TO: Corcoran City Council

FROM: Kendra Lindahl, Landform

DATE: December 16, 2013 for the December 23, 2013 City Council Meeting

RE: Preliminary PUD Development Plan, Preliminary Plat and Rezoning to PUD (Planned Unit Development) for U.S. Home Corporation (dba Lennar) for a residential development called "Ravinia" at Gleason Road and County Road 101 (PID 36-119-23-13-0007, 36-119-23-13-0005, 36-119-23-14-0005, 36-119-23-14-0003, 36-119-23-14-0006, 36-119-23-43-0001, 36-119-23-41-0002, 36-119-23-41-0003, 36-119-23-24-0001, 36-119-23-24-0003, 36-119-23-21-0001) (City File 13-025)

SECTION A - A'

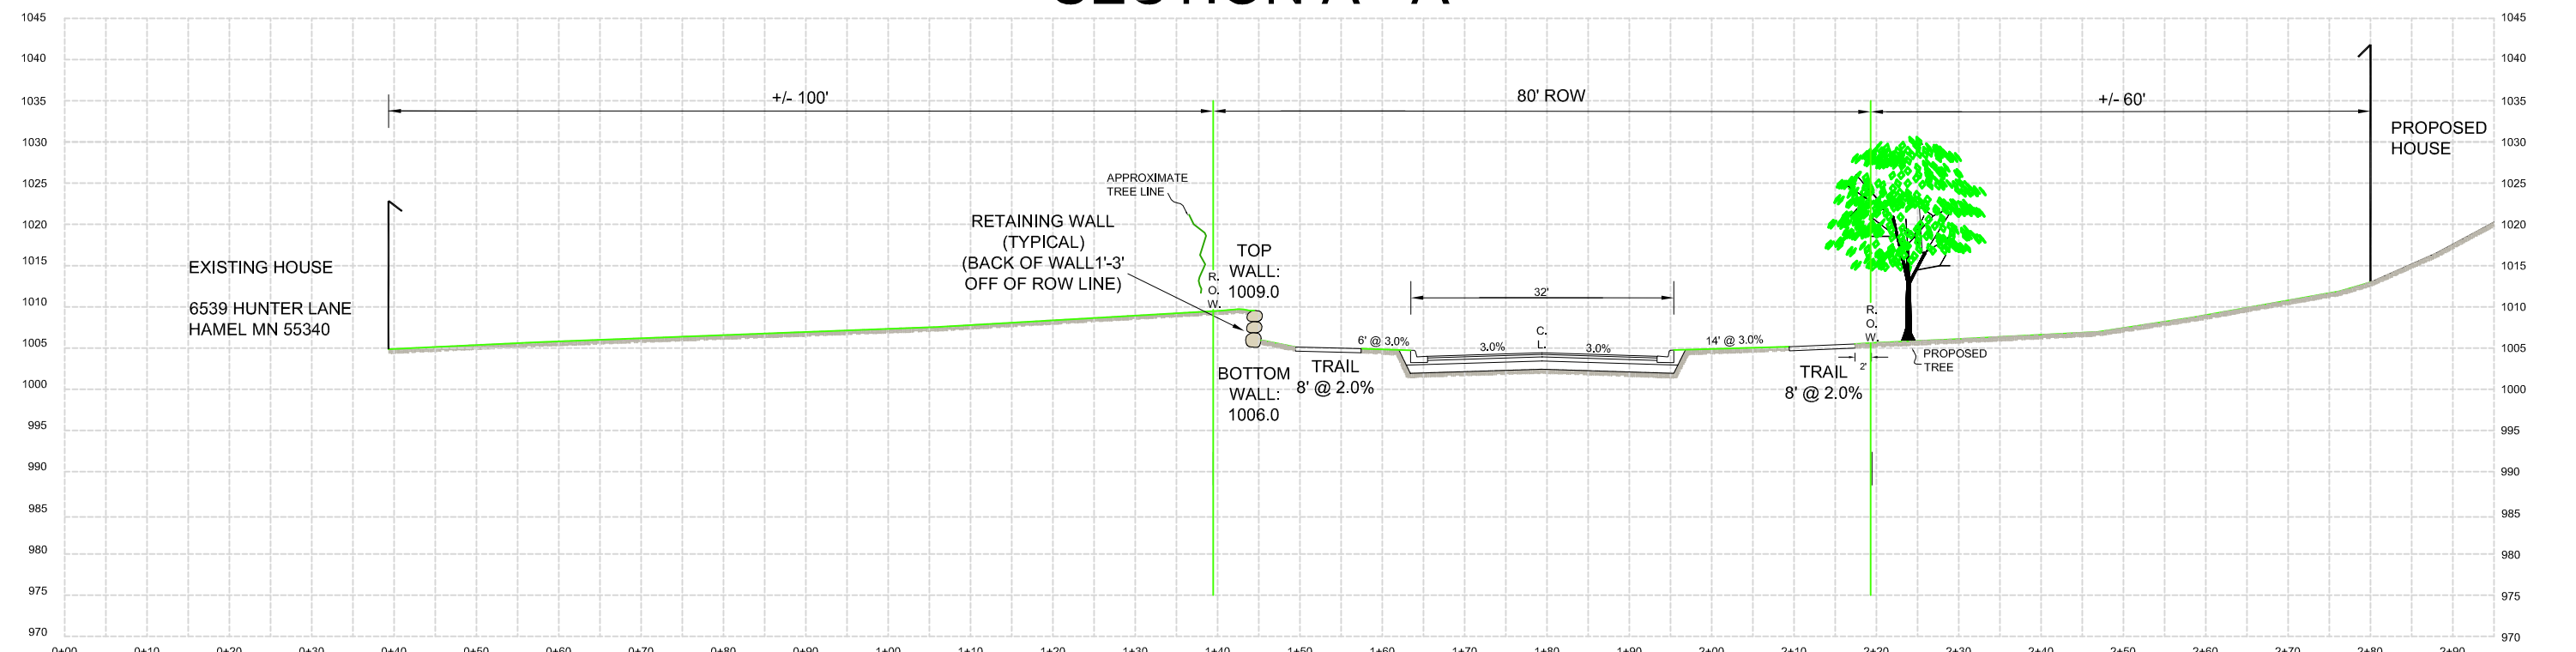
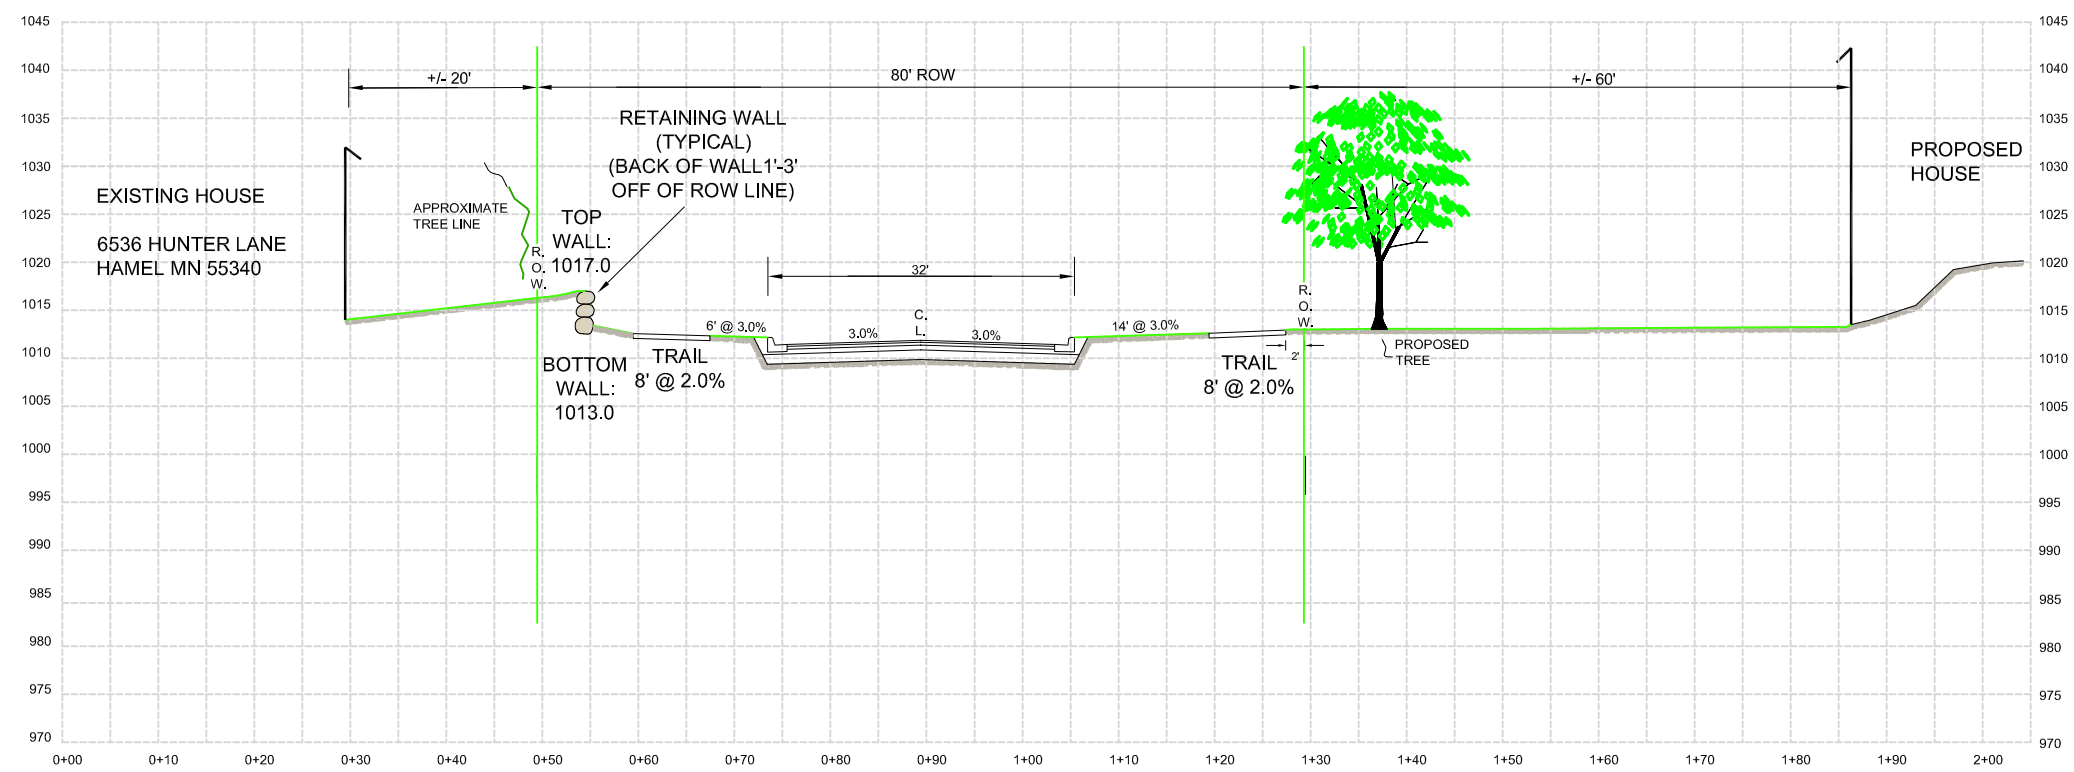
The applicant provided cross-sections showing the relationship between Gleason Parkway and the Hunter Lane properties.

The Planning Commission recommended that Lennar work with the adjacent landowners on western Gleason to try to provide some sort of buffer. Hennepin County records show that only two properties will abut the new road right-of-way:

As noted by staff at the public hearing, there are overstory trees planned in the boulevard between the trail and new street. The Comprehensive Plan shows a trail on both sides of this collector road way. Staff, the Parks and Trails Commission and the Planning Commission all recommended that these trails remain. Consequently, there is little space within the right-of-way to accommodate any additional trees.
